April 16, 2021

**ADDENDUM NO. 3**  
**TO CONTRACT DOCUMENTS FOR THE**  
**LOWER PENITENCIA CREEK IMPROVEMENTS PROJECT**  
**Project No. 40334005 Contract No. C0655**

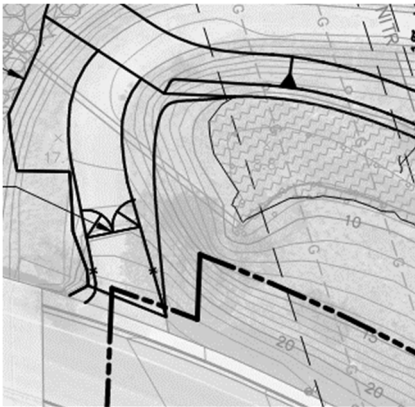
Sheet C-01 What is the section for the left entrance on this sheet? [image attached]

The existing left entrance access road from McCarthy Blvd will be graded down to match the 4' bench. The typical cross section will be Detail L/Sheet C-14 for typical aggregate base maintenance road.
